PRODUCT UPDATE BULLETIN

Dec 7, 2022

New TX3 Products with -256 suffix

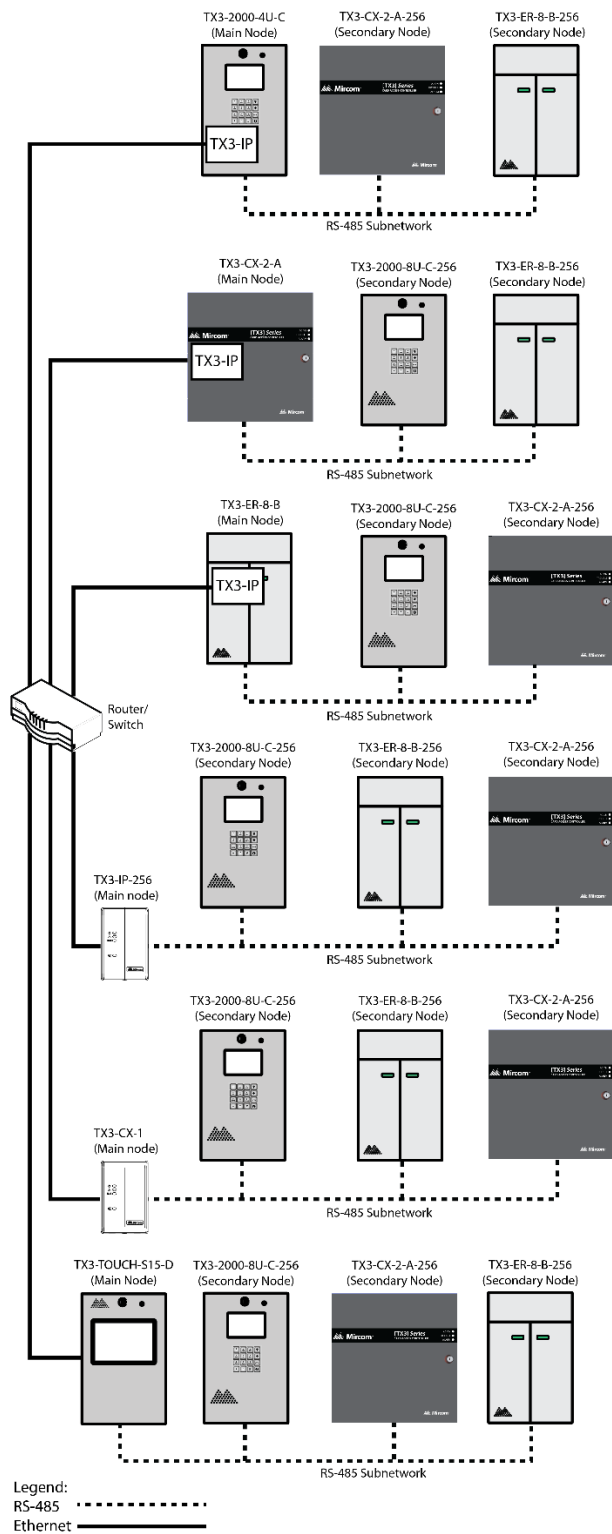
Please also refer below Figure; it shows a mixed network with both old and new (-256) models. Old and new TX3 models can be on the same RS-485 network.

TX3-2000-4U-C (Main Node) — TX3-CX-2-A-256 (Secondary Node) — TX3-ER-8-B-256 (Secondary Node) — RS-485 Subnetwork

TX3-CX-2-A (Main Node) — TX3-2000-8U-C-256 (Secondary Node) — TX3-ER-8-B-256 (Secondary Node) — RS-485 Subnetwork

TX3-ER-8-B (Main Node) — TX3-2000-8U-C-256 (Secondary Node) — TX3-CX-2-A-256 (Secondary Node) — RS-485 Subnetwork

TX3-2000-8U-C-256 (Secondary Node) — TX3-ER-8-B-256 (Secondary Node) — TX3-CX-2-A-256 (Secondary Node)
TX3-IP-256 (Main node) — RS-485 Subnetwork

TX3-2000-8U-C-256 (Secondary Node) — TX3-ER-8-B-256 (Secondary Node) — TX3-CX-2-A-256 (Secondary Node)
TX3-CX-1 (Main node) — RS-485 Subnetwork

TX3-TOUCH-S15-D (Main Node) — TX3-2000-8U-C-256 (Secondary Node) — TX3-CX-2-A-256 (Secondary Node) — TX3-ER-8-B-256 (Secondary Node) — RS-485 Subnetwork
